Subject: TRIMMED: Objection to DA MOD2022/0471 attention Adam Susko

Subject: Development DA 2019/0154 – 1955 Pittwater Road, Bayview

Mod 2022/0471 (29/9/2022)

Lower Garden View & Privacy Impact – near boundary fence including view onto proposed roof top terrace and 'single storey' on rear 25% set back.

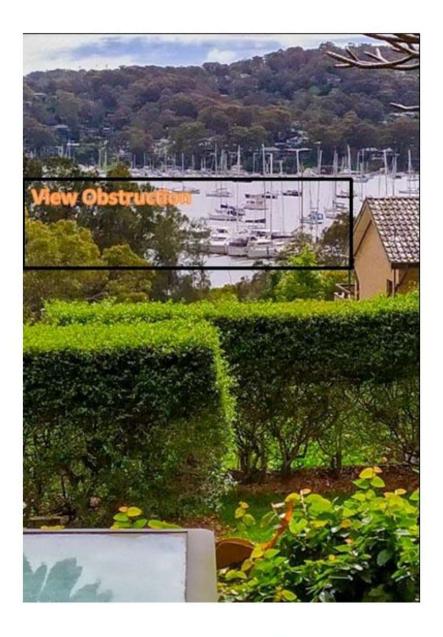
Substantial. Privacy, noise and shadowing concerns

Rumpus Lower Deck/Entertaining Area View & Privacy Impacts

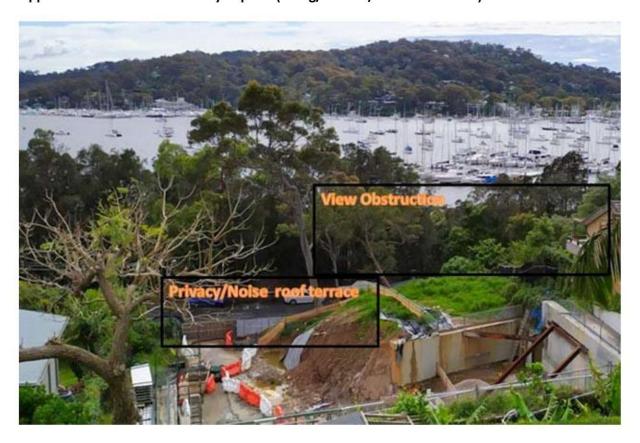
Pool Garden/Entertaining Area View & Privacy Impacts

APPENDIX-4 MISSING PLAN DRAWING DETAILS.

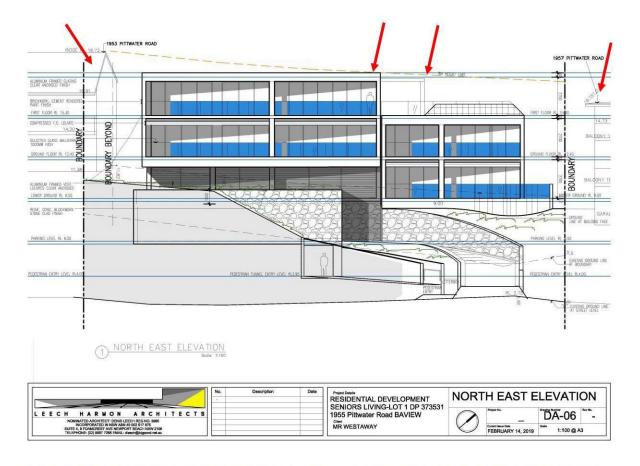
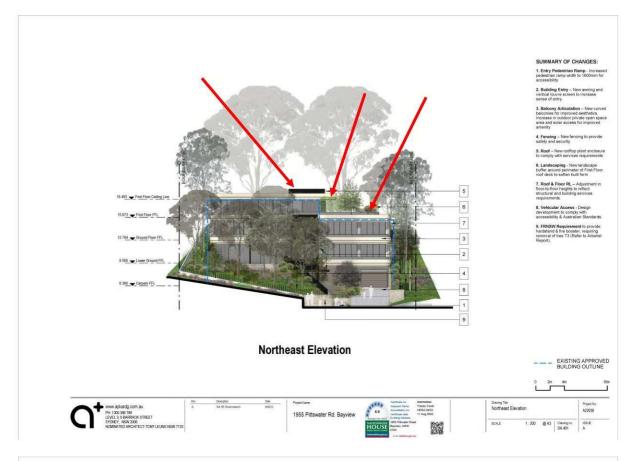
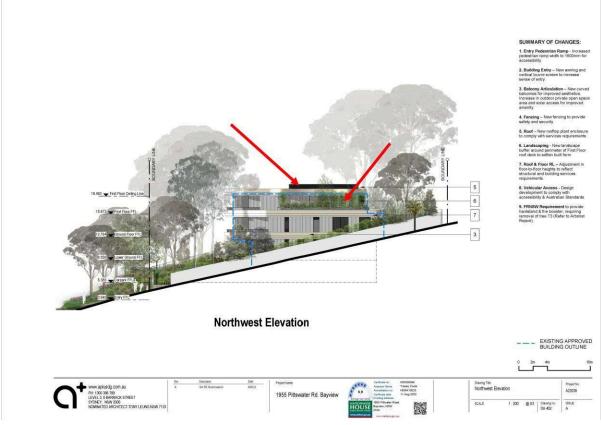
A complete set of drawings be provided to assess the impact of the changes proposed rather than the 'selected' ones provided in the modification request. In particular, the revised NE elevation showing the 8m height limit shown on the original DA submission and the adjoining property roof lines to enable the bulk of the new proposal to be better evaluated. Should these show an issue where the developer has not been forthcoming then we would like an independent view of the plans and land survey be conducted by the council or ourselves?

NOTE – THE NW ELEVATION APPEARS TO SHOW A MAJOR NONCOMPLIANE ON THE 8.0M HEIGHT LIMIT AT BOUNDARY. UPDATED DRAWING (INCLUDING THE HOUSES ON EITHER SIDE OF THE DEVELOPMENT) BE PROVIDED TO ENABLE BULK AND VIEW IMPACTS TO BE PROPERLY ASSESSED.
